Department of Energy
Washington, DC 20585

Mr. B.J. Youngblood, Chief
Operations Branch
Division of High-Level Waste Management
Office of Nuclear Material Safety
and Safeguards.

Attached for your review are the responses to the NRC's Request for Additional Information (RAI) on the BWIP QA Plan Revision "1" and the Basalt Quality Assurance Requirements Document (BQARD), Revision "0" (Refer to attached RAI dated March 9, 1987).

FIGURE 1-2

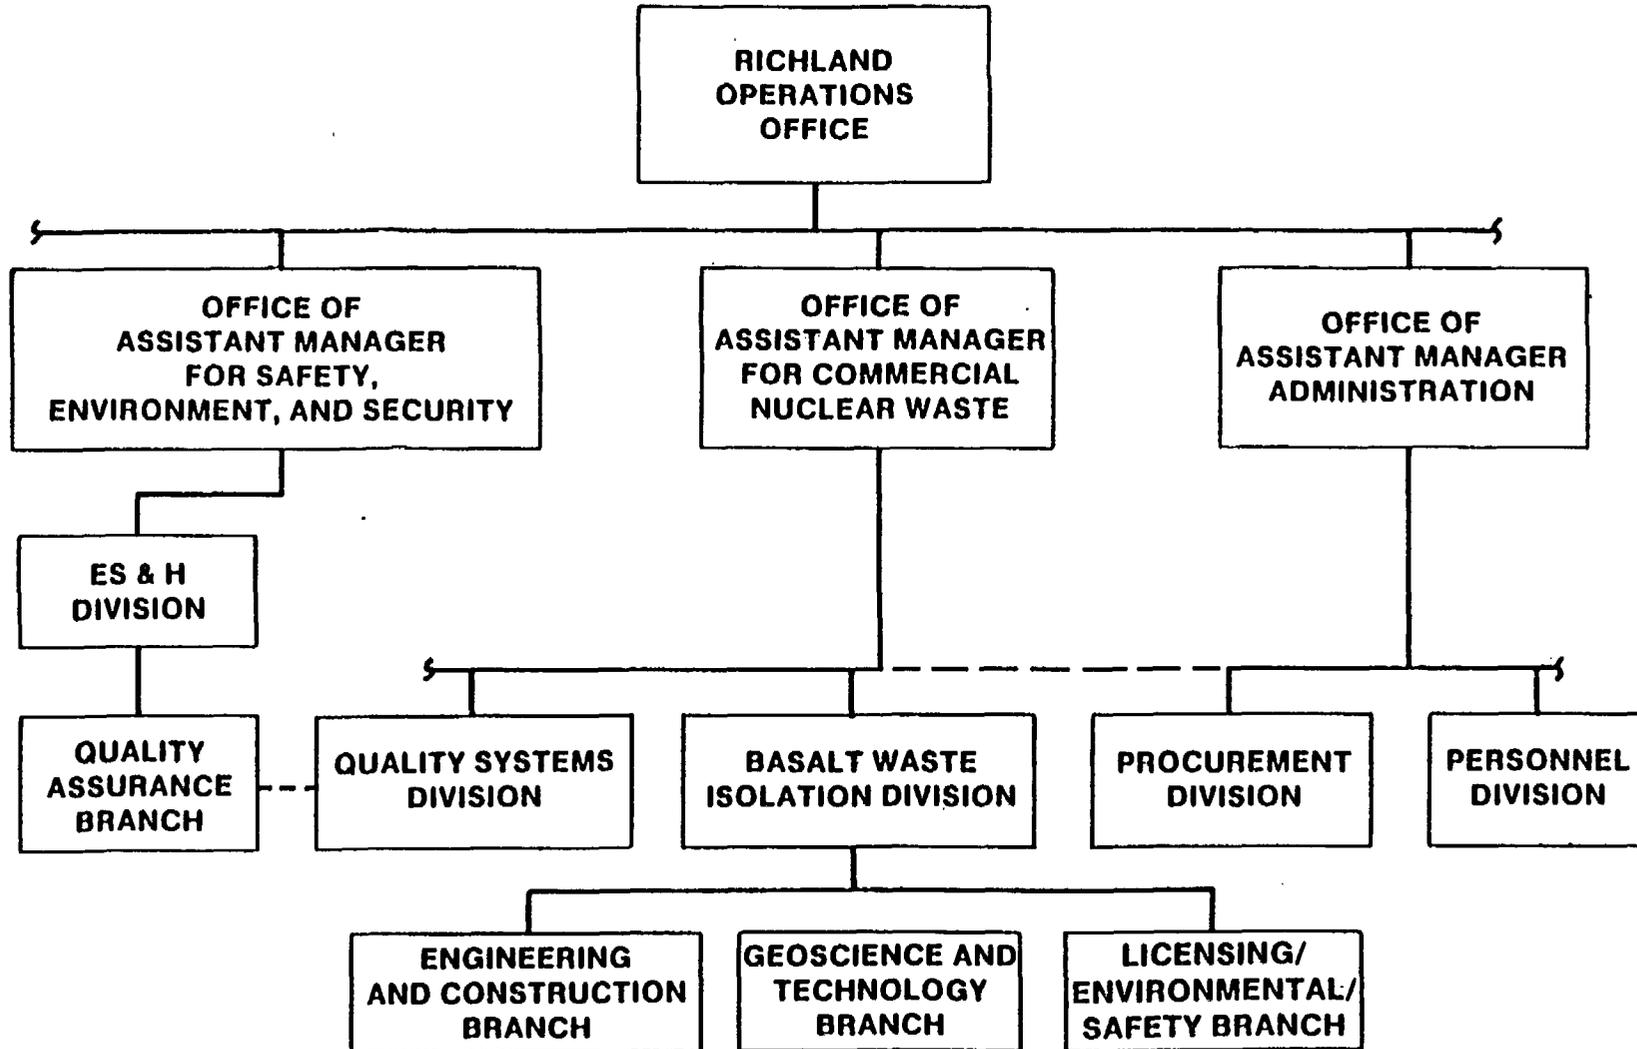
7. Clarify whether the Director, BWI Division, reports through the Office of Commercial Nuclear Waste (Section 1.3.1) or the Office of Civilian Nuclear Waste (Figure 1-2). Identify the onsite and offsite organizational elements which function under QA program controls or justify not doing so. Show the ES&H Division, the Procurement Division, and the Personnel Division on an organization chart. (1.7)

7. Clarify whether the Director, BWI Division, reports through the Office of Commercial Nuclear Waste (Section 1.3.1) or the Office of Civilian Nuclear Waste (Figure 1-2). Identify the onsite and offsite organizational elements which function under QA program controls or justify not doing so. Show the ES&H Division, the Procurement Division, and the Personnel Division on an organization chart. (1.7)

FIGURE 1-3 BWI PROJECT QA PROGRAM MANAGEMENT RESPONSIBILITIES

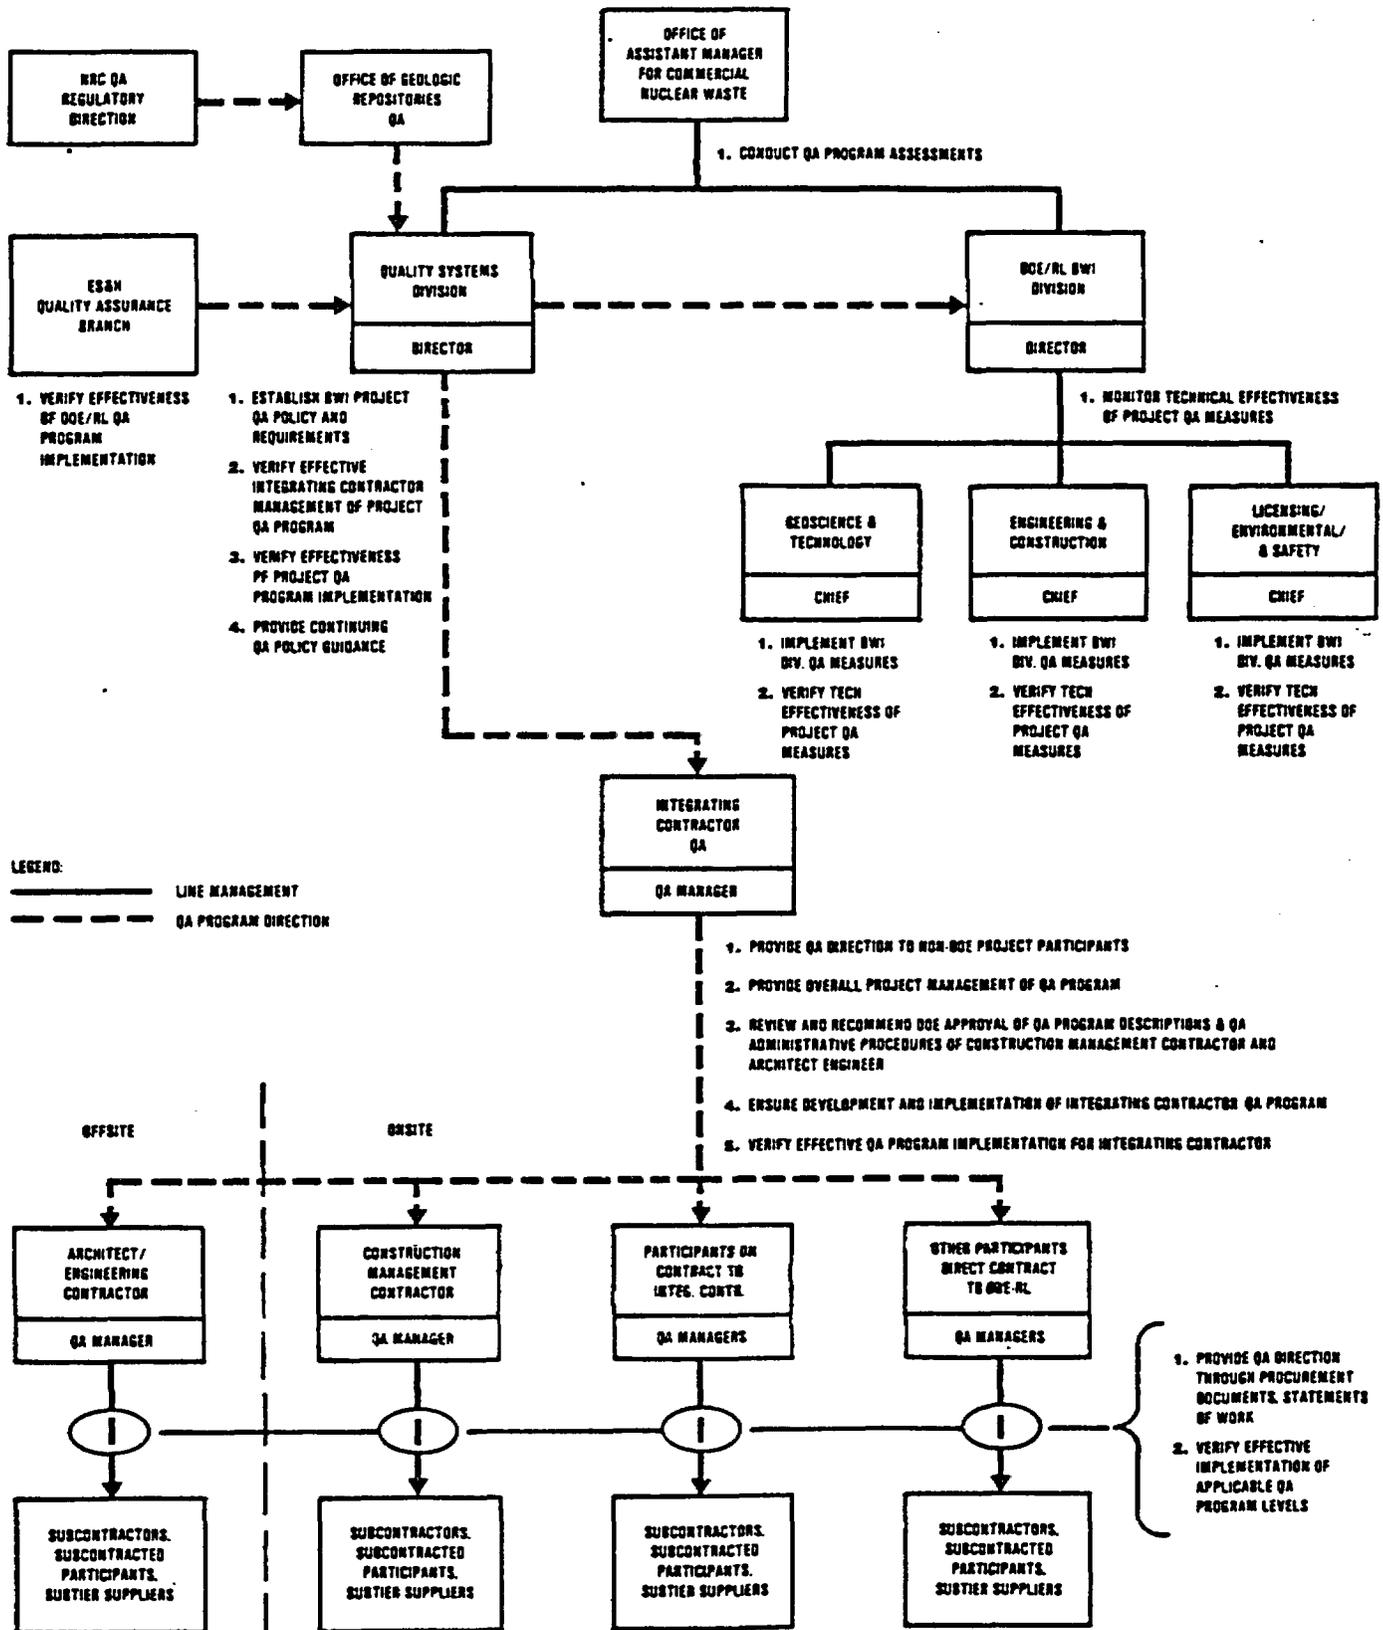
3. Section 1.3 and Appendix A of the plan describe QA responsibilities within the BWI Division. Identify who (by position title) in the Richland Operations Office is responsible for the overall BWI program. Clarify the meaning of the dashed lines, arrowheads, and ellipses on Figure 1.3 of the plan. Also indicate what ESH stands for on Figure 1.3 and in Section 1.5 of the plan. (1.1)*

3. Section 1.3 and Appendix A of the plan describe QA responsibilities within the BWI Division. Identify who (by position title) in the Richland Operations Office is responsible for the overall BWI program. Clarify the meaning of the dashed lines, arrowheads, and ellipses on Figure 1.3 of the plan. Also indicate what ES&H stands for on Figure 1.3 and in Section 1.5 of the plan. (1.1)*
